# Product Change Notification

**Change Notification #:** 112863 - 00  
**Change Title:** Boxed Intel® NUC Kit D34010WYK, 5 Pack,  
Boxed Intel® NUC Kit D54250WYK, 5 Pack,  
PCN 112863-00, Product Marking  
Update Power Input Text and Display Port  
Icon on Chassis  
**Date of Publication:** February 3, 2014

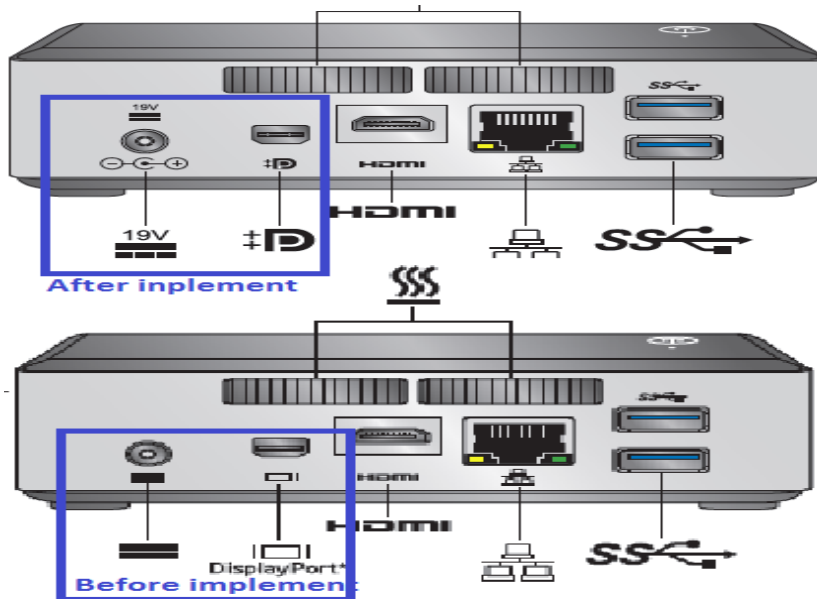
The text on the back panel of the chassis will be updated to show 19V, the polarity for the power input and to correct the display port. See the below picture for details.
